**CITY OF TEMPE  
DEVELOPMENT REVIEW COMMISSION**

**Meeting Date: 07/08/2014  
Agenda Item: 5**

**ACTION:** Request for a Development Plan Review for a new hotel for **AC BY MARRIOTT AT HAYDEN FERRY LAKESIDE**, located at 100 E Rio Salado Parkway. The applicant is Woodbine Development Corporation.

SHEET NO.  
**L1.01**

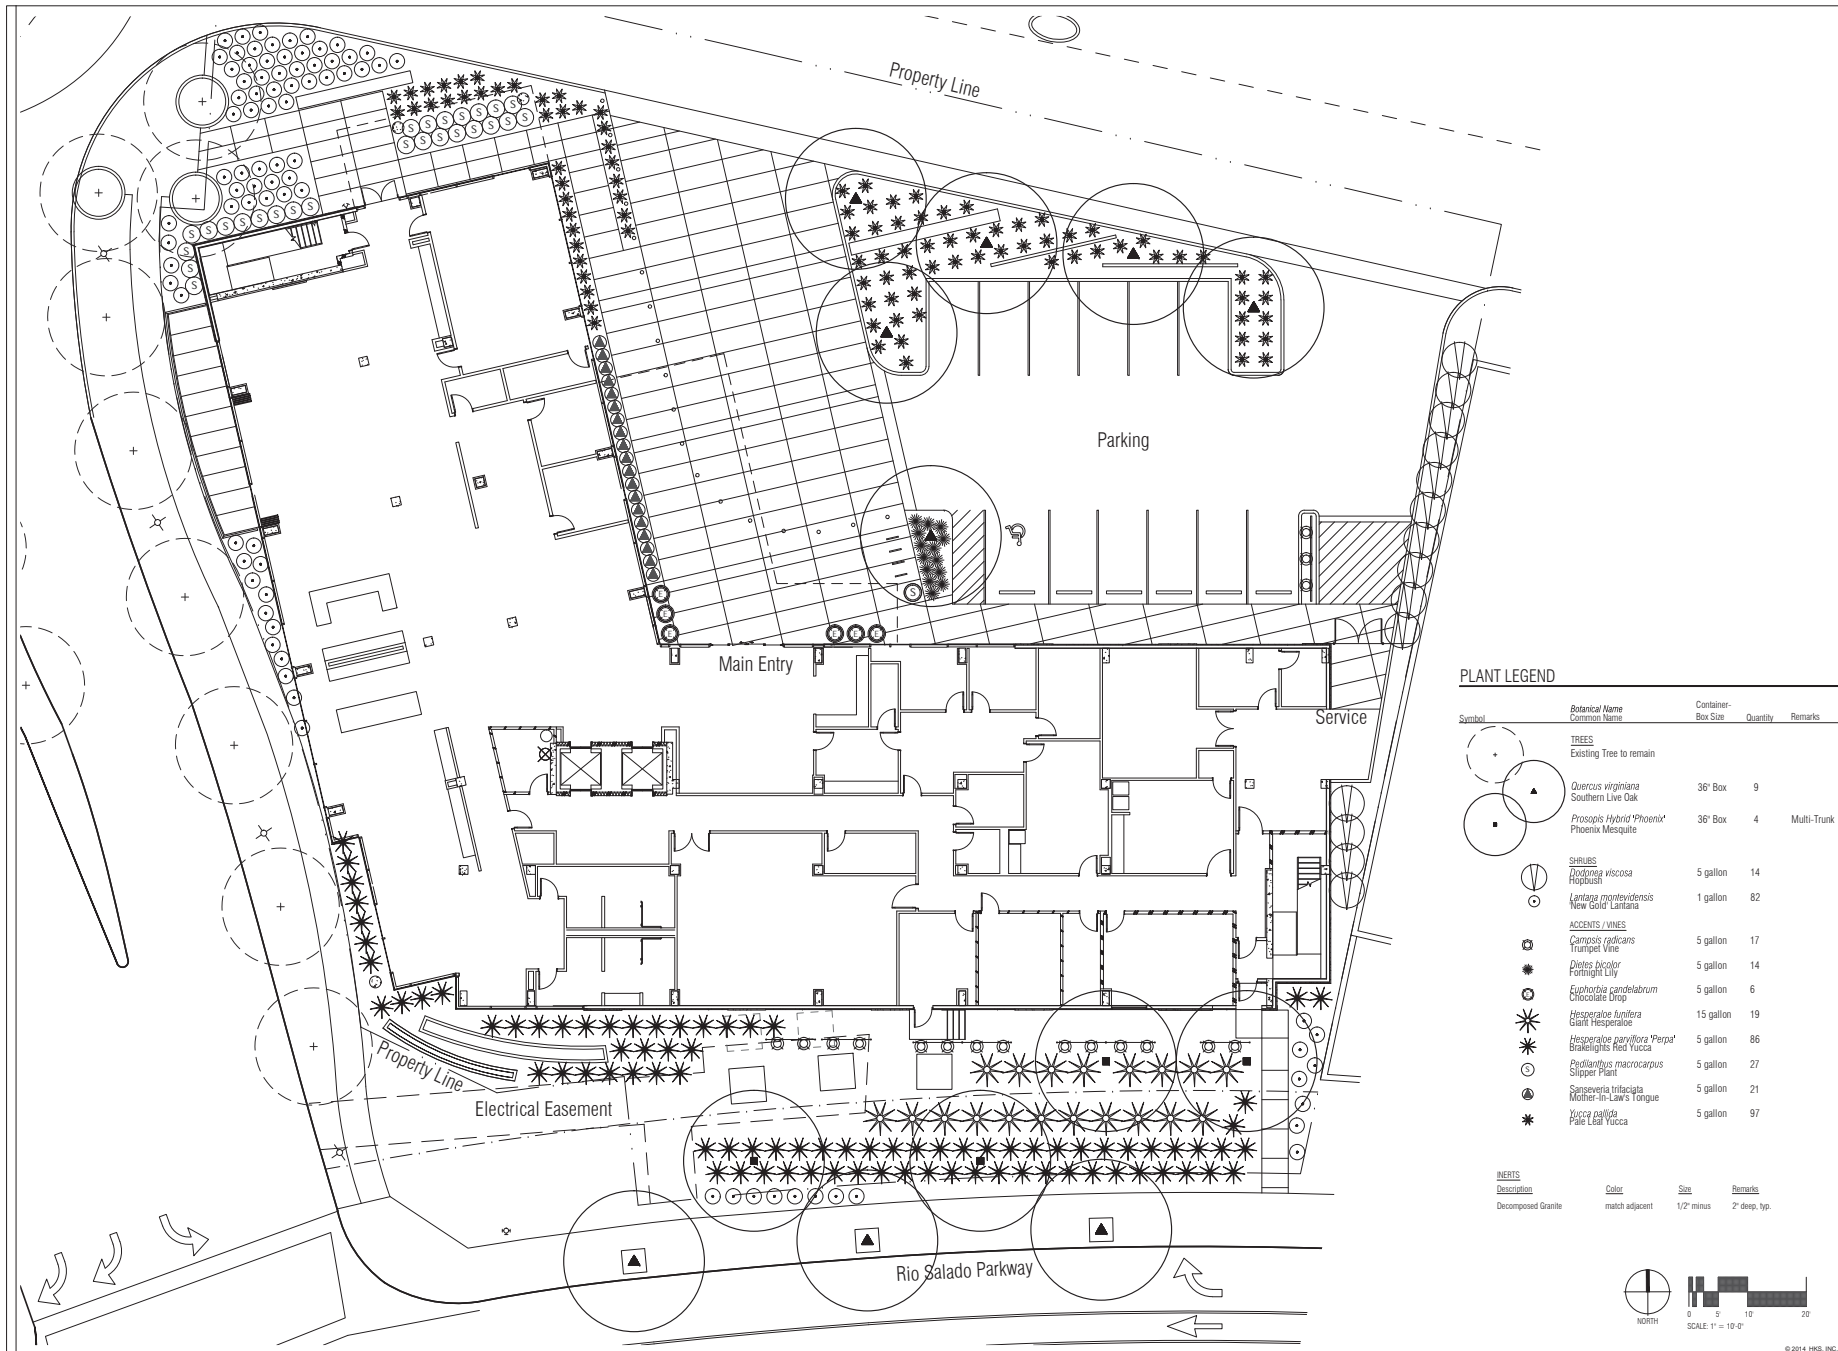
24. Coordinate landscape plan, floor plan and elevations to show the relationship of doors and vents on the ground floor elevation and landscape plan: coordinate the location of the green screens to address security of the street front back of house condition. Screens shall align architecturally with other vertical and horizontal elements on the building, such as decorative accent bands in the masonry and door heights. Green screens shall be placed within 8" of the building wall, unless the green screen is located where there is a door or building vent. Green screens set away from the building wall for exiting and ventilation purposes shall be designed for security as recommended by Police and Planning staff.

25. The plant palette is approved as proposed and specified on the landscape plan. Any additions or modifications may be submitted for review during building plan check process.

26. Provide Heritage Oak Trees within tree grates located in the public sidewalk along Rio Salado Parkway, to match the streetscape of the adjacent buildings.

01 - LEVEL 1 FLOOR PLAN  
1/8" = 1'-0"

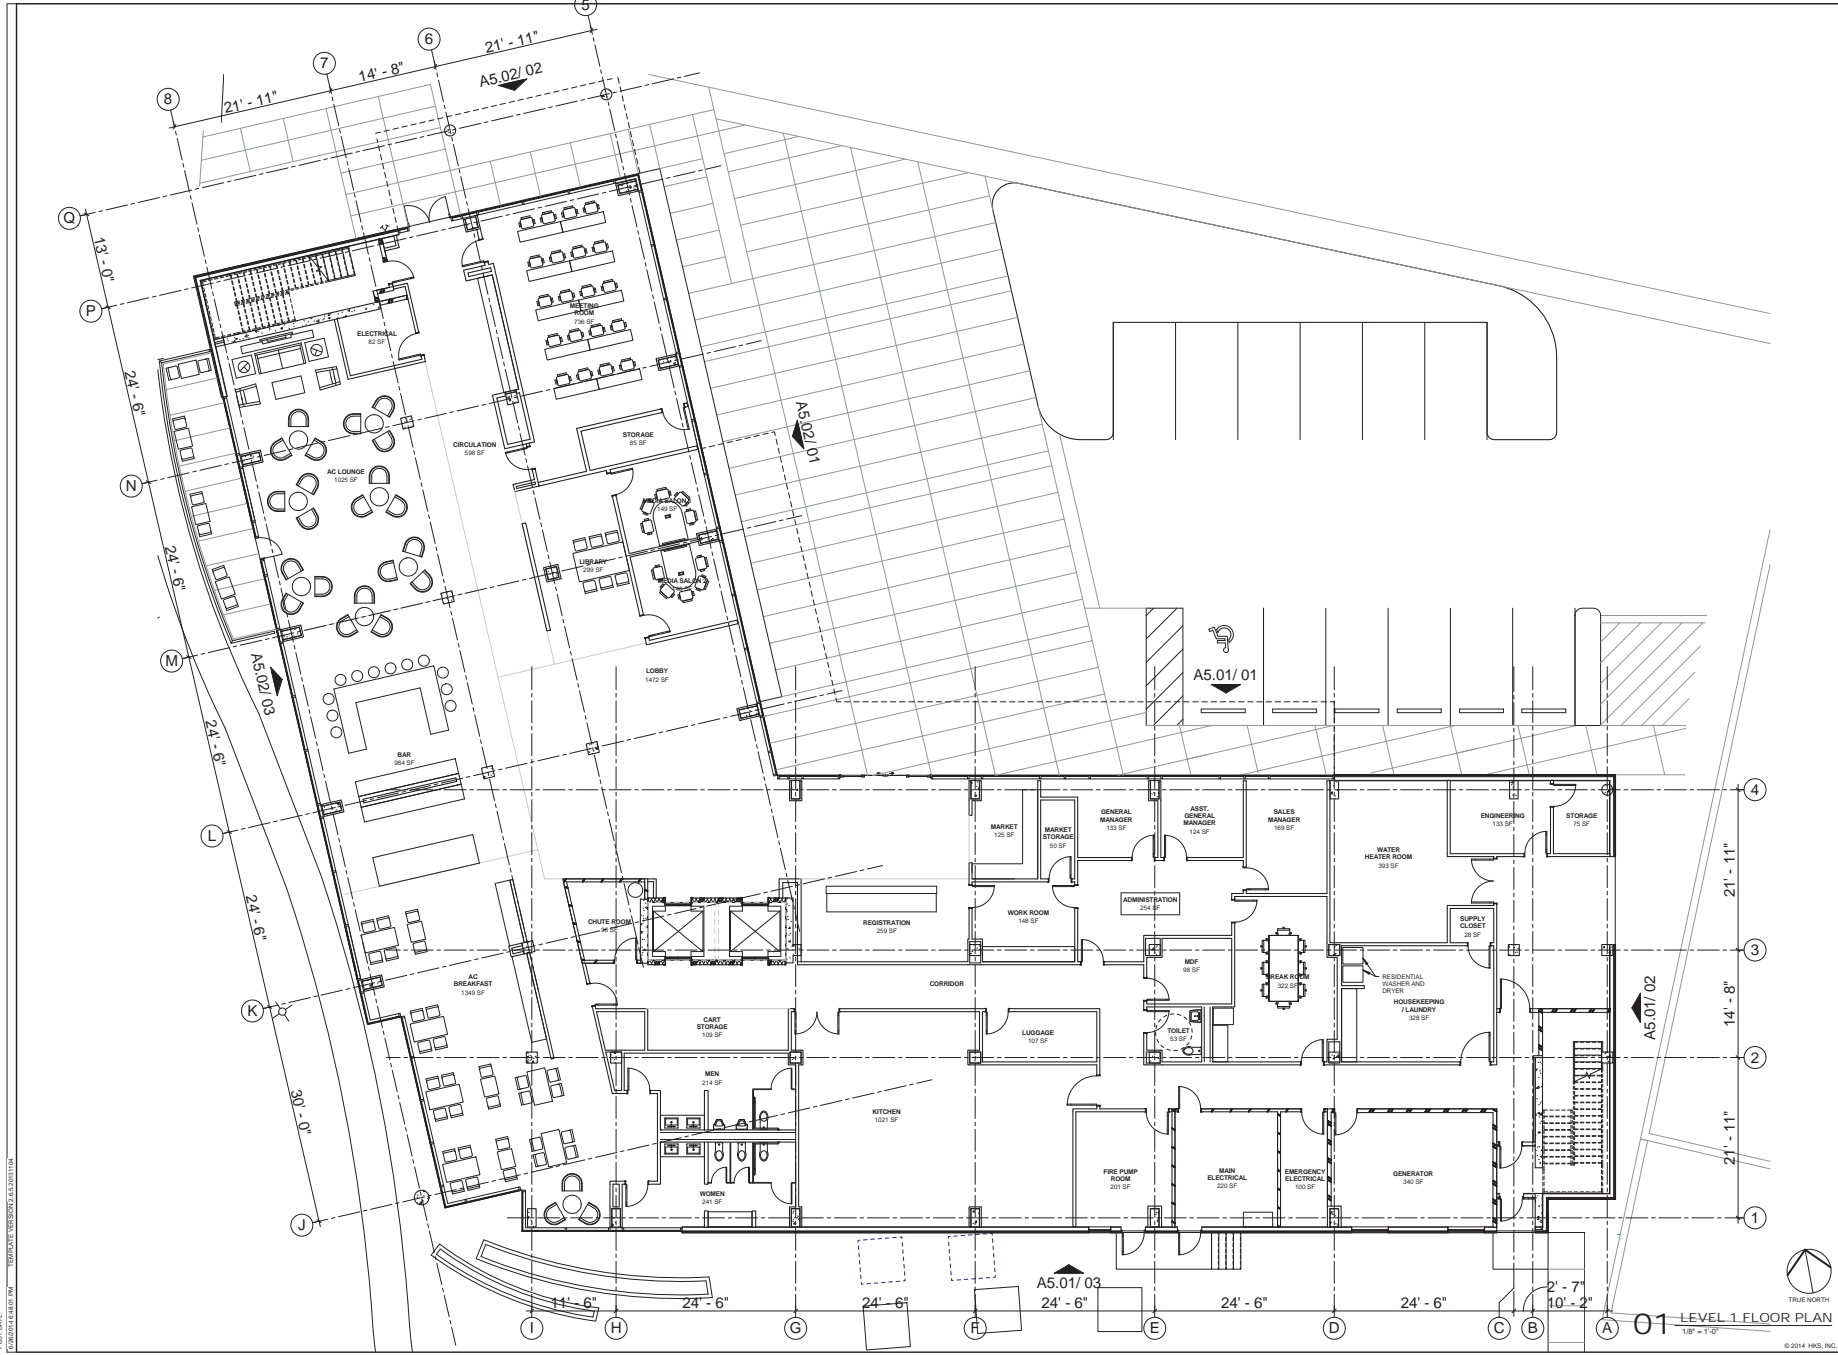
11. Exit Security:
  - a. Provide visual surveillance by means of fire-rated glazing assemblies into adjacent circulation spaces.
  - b. In instances where an elevator or stair exit is within 21'-0" of an alcove, corner or other potential hiding place, position a refracting mirror to allow someone in the exit doorway to observe in the mirror the area around the corner or within the alcove that is adjacent to the doorway.
12. Public Restroom Security:
  - a. Lights in restrooms:
    - 1) Provide 50% night lights
    - 2) Activate by automatic sensors, key or remote control mechanism
  - b. Single user restroom door hardware:
    - 3) Provide a key bypass on the exterior side

SHEET NO.  
**A5.04**

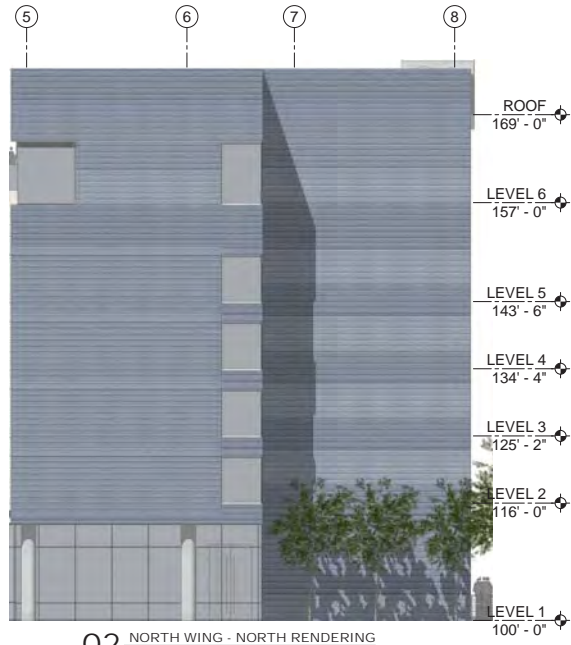
13. Coordinate floor plan and elevations to show the relationship of doors and vents on the ground floor elevation to be architecturally integrated into the façade: align accent band with the top of the door heights and mount vents to match the accent band and door heights for a consistent look along the street front.
14. No more than 25% of the building envelope shall be EIFS, in accordance with the design guidelines of Hayden Ferry Lakeside. The use of masonry, natural stone, metal or glazing products would be acceptable substitutes to meet the intent.
15. Integrate the Hayden Ferry design concepts, including a curved element into the pedestrian level façade of the building to incorporate the nautical theme of the master planned design aesthetic.

16. The materials and colors are approved as presented:
  - Roof – flat parapet
  - Primary Building – EIFS DRYVIT – freestyle (suede) texture– Thundercloud Grey color

- Primary Building – Architectural metal Panel – VM ZINC or similar – VMZ Pigmeto Blue color
  - CMU – integral colored grey, honed finish to match existing office buildings

- CMU accents – Astra A84ST8 HLW (ebony) integral colored black, polished finish to match existing office buildings
  - Anodized aluminum frame
  - Glazing – PPG Solarban R100 Opticblue and ClearProvide main colors and materials with a light reflectance value of 75 percent or less. Specific colors and materials exhibited on the materials sample board are approved by planning staff. Additions or modifications may be submitted for review during building plan check process.
